TECHNICAL BULLETIN

Convertible Soft Top – Replacing Outer Cover – Guidelines

76-124

MODEL 1989-96 MY XJS Convertible DATE 12/97

ILLUSTRATION 1

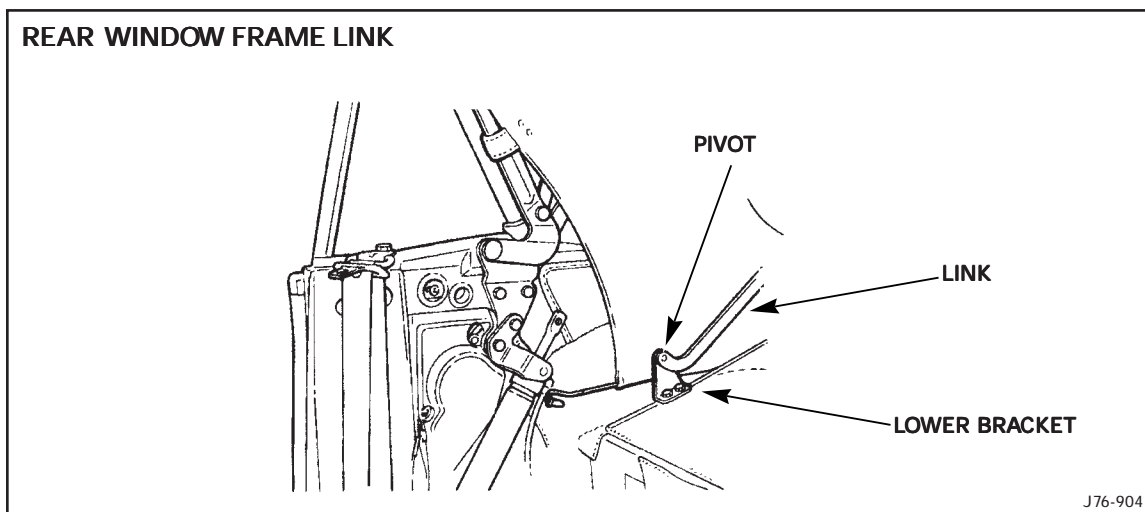
- Mark the location of the tonneau loops using masking tape.
- Cut the rear glass out **before** removing the outer cover from the vehicle. This approach provides better support when cutting the sealant and eliminates the steps required to disconnect the rear window frame webbing and links.
- To avoid contact between the rear window frame and the rear seats on 2+2 models, make sure that the pivots of the links for the frame move freely (Illustration 1). Lubricate the pivots, if necessary.
- Loosen the mounting bolts of the lower brackets of the rear window frame links. Slide the lower brackets **completely forward** and tighten the bolts (Illustration 1). This full adjustment range may be necessary later if the material between the frame and the body is wrinkling and needs more tension.

ILLUSTRATION 2

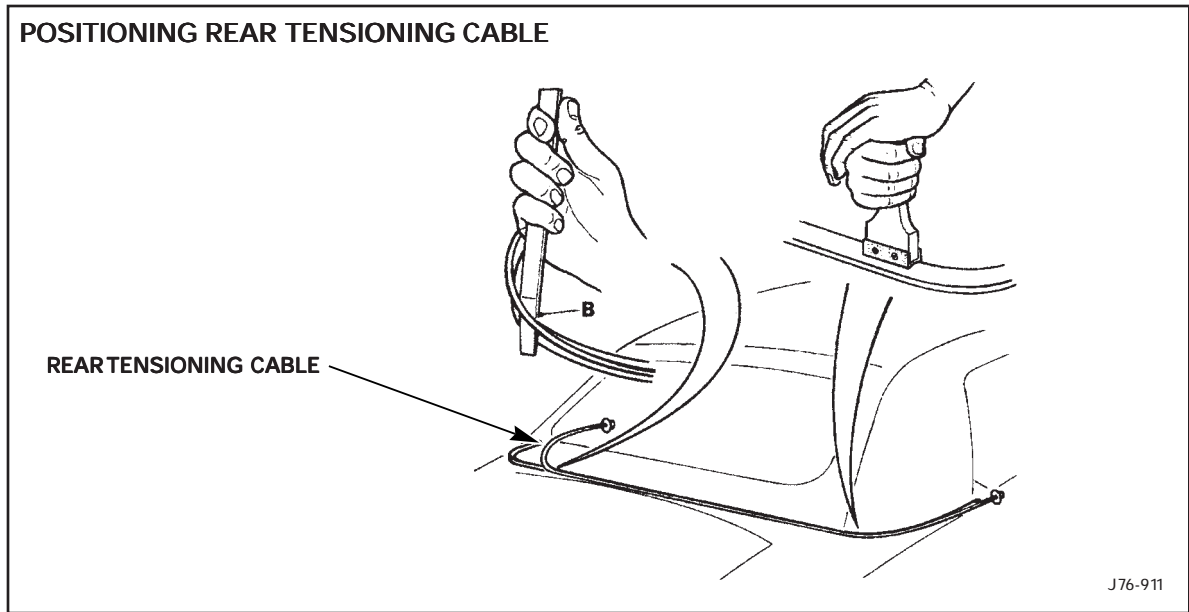
- Apply masking tape to light colored covers to avoid staining the material during installation work.
- An alternative to fabricating the lever tool 'B' (Illustration 2), is to loop a scrap piece of plastic box strapping behind the rear tensioning cable and use it to pull the cable into place in the channel. This avoids the need to pry against the vehicle body.
